SERVICE INFORMATION LETTER NO. 0165

Revision 4

1. SUBJECT: Tail Rotor P/C Link Installation Inspection
2. MODEL: F-28C, F-28C-2, F-28C-2R, F-28F, F-28F-R, 280C, 280F, and 280FX
3. EFFECTIVITY: F-28 Series, All; 280 Series, All
4. BACKGROUND:

Figure 1. Tail Rotor Rotating Controls

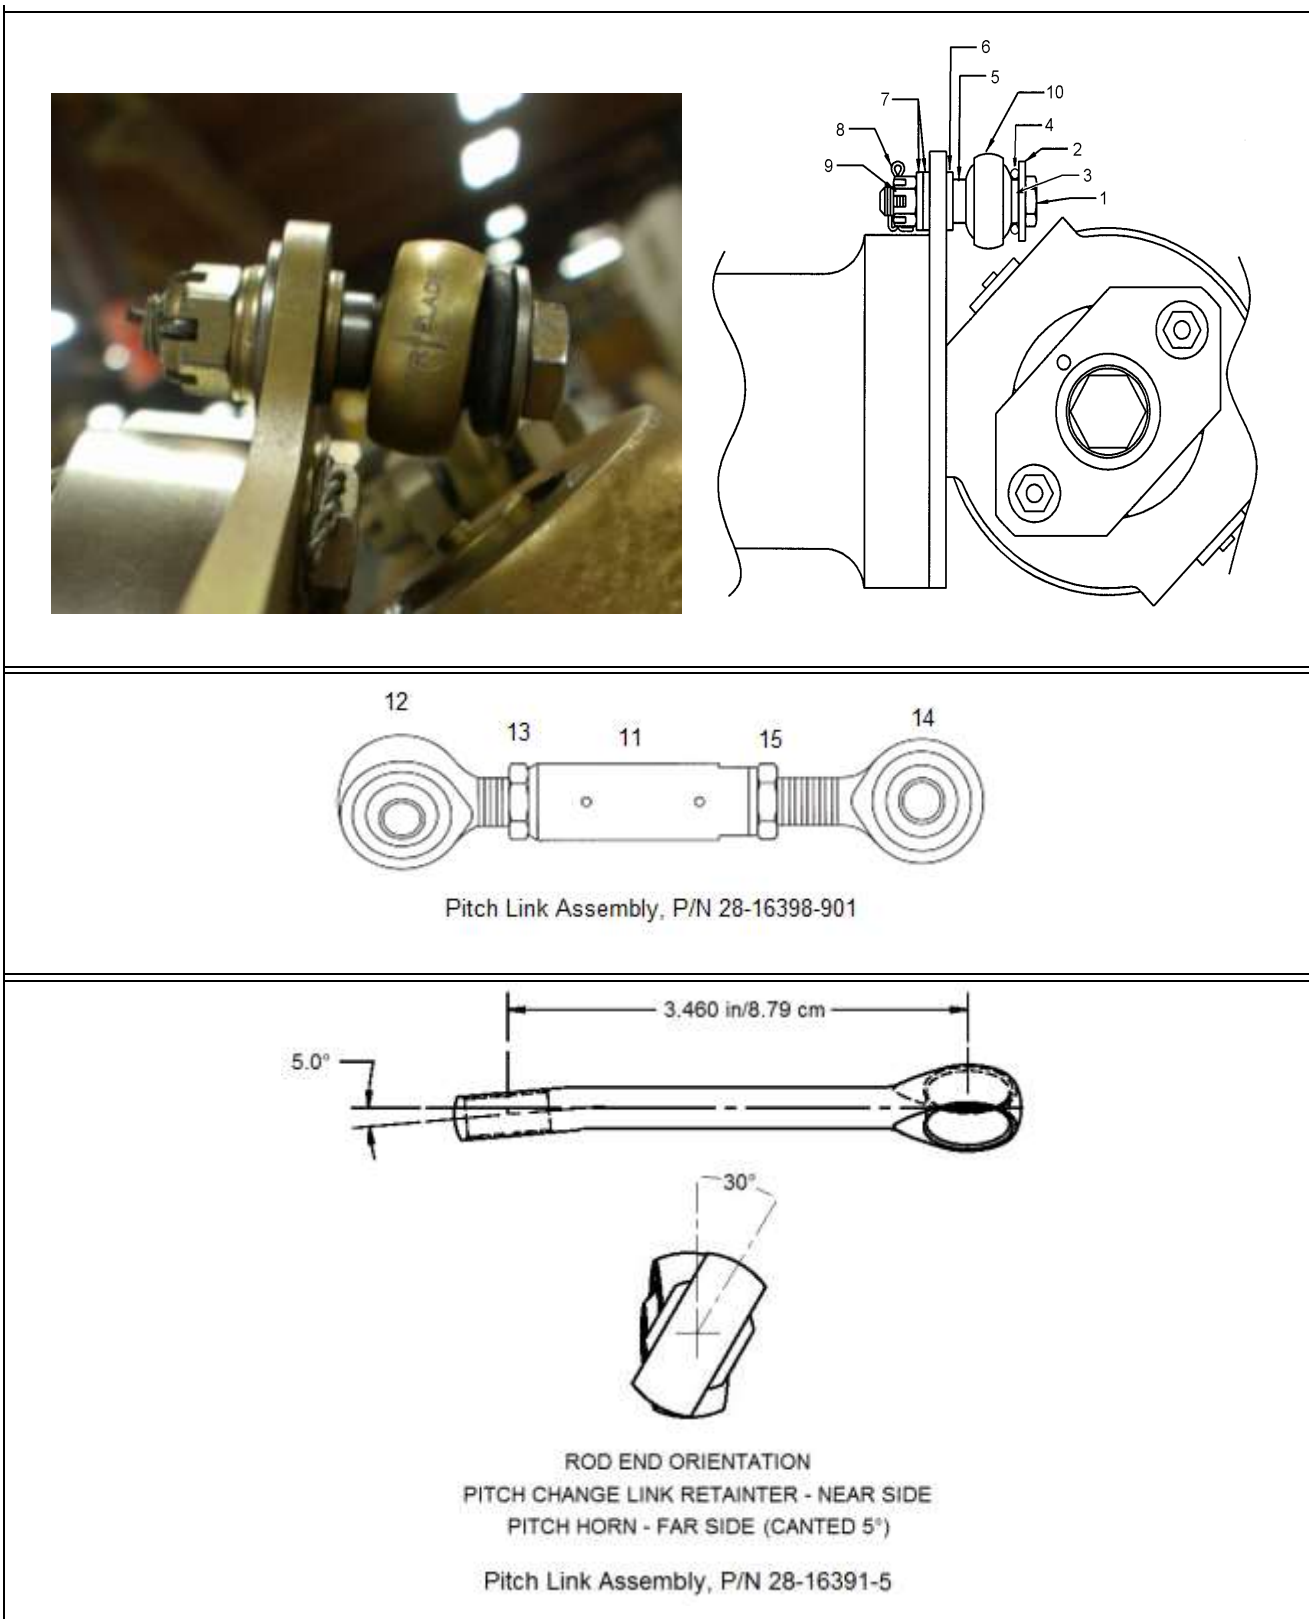
Revision 4 replaces AN960-416 washers (cad plated carbon steel) with NAS1149C0463R washers (passivated stainless steel). (Revision 4 supersedes SIL0165 Revision 3.)

Revision 4 changes the number of models affected by the contents of this SIL, and incorporates information on required washer replacement.

5.1.1 Inspect both tail rotor pitch link change installations for proper and secure installation hardware in accordance with Figure 1.

- 5.1.8 Connect the pitch change link (10) to the pitch arm with the hardware in the following sequence: bolt (1) (bolt head installed in the direction of rotation), Harper washer (2), thin spacer (3), O-ring (4), pitch change link rod end (10), thick spacer (5), washer (6), pitch arm, washer(s) (7), and nut (9). Torque the nuts (55-75 in-lbs/6.2-8.5 Nm) and install new cotter pin (8).

5.2.1 Remove and install the tail rotor pitch change link assemblies in accordance with the applicable maintenance instructions for each model aircraft and in accordance with step 5.1.8 above. **NOTE:** The P/N 28-16391-5 (and P/N 28-16391-3) tail rotor pitch link assembly has the label “T/R↑BLADE” etched on the rod end that is canted 5°. This end must attach to the tail rotor and the arrow must point toward the tail rotor blade (see photo in Figure 1).

* Use as required for dynamically balancing the tail rotor. Each AN960 washer is to be replaced with its equivalent size NAS1149C04XXR washer.

** Install each pitch change link assembly with the rod end labeled T/R↑BLADE on the tail rotor pitch horn side with arrow pointing toward the tail rotor blade.
